Memorandum

To: CCBWQA Technical Advisory Committee
CC: Chuck Reid, Manager
From: William P. Ruzzo, P.E.
Date: December 27, 2010
Re: Cherry Creek Stream Reclamation at PJCOS – Modified Design

An analysis was conducted to identify water quality impacts due to changes in the design for the Cherry Creek Stream Reclamation at Parker Jordan Centennial Open Space (PJCOS). The purpose of this memorandum is to present the results of a quantitative analysis to assess the changes in water quality benefits associated with the modified design for the PJCOS reach of Cherry Creek.

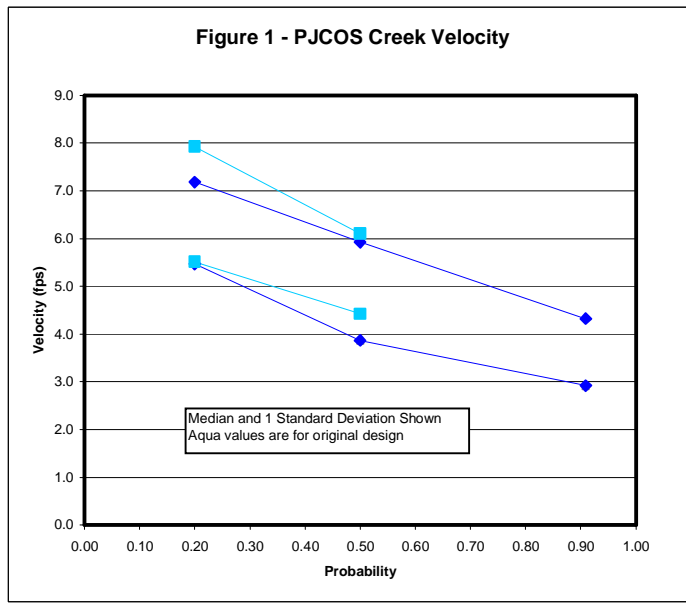
Figure 1 below shows that the modified design velocities are slightly lower for both the median and one standard deviation. This comparison suggests that the modified design is a slight improvement over the original design.

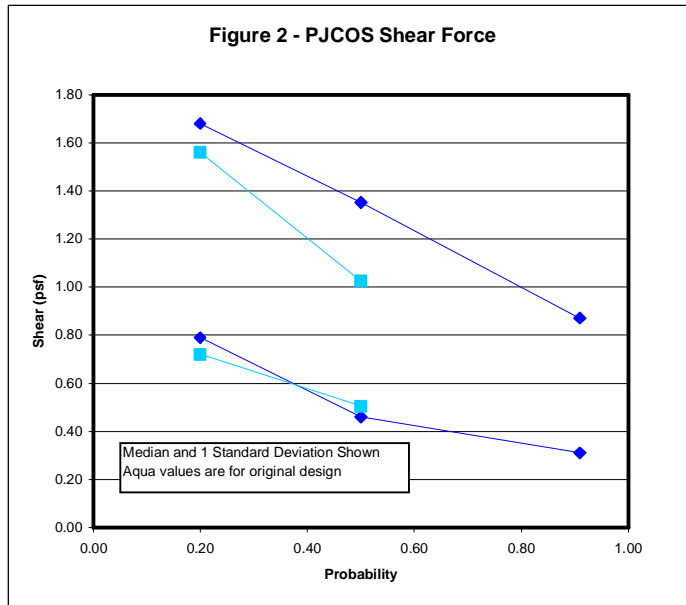
Figure 2 below shows that the shear force for the modified design is about the same for the median value, but has a greater variability throughout the channel reach. This comparison suggests that the modified design *may* result in *lesser* water quality benefits than the original design but the comparison may also be inconclusive.

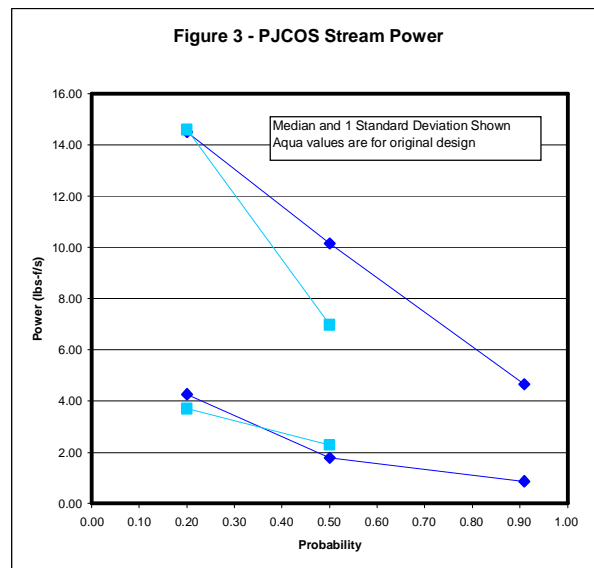
Figure 3 below shows that the stream power for the modified design is about the same for the median value, but has a greater variability throughout the channel reach. This comparison suggests that the modified design *may* result in *lesser* water quality benefits than the original design but the comparison may also be inconclusive.

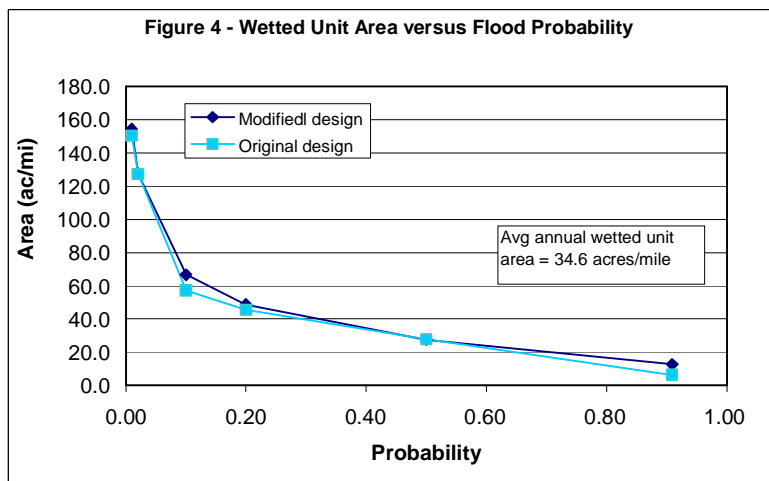
Figure 4 below shows that the wetted area for the modified design is slightly greater than for the original design, which results in a higher average annual wetted area. This comparison suggests that the modified design is a slight improvement over the original design.
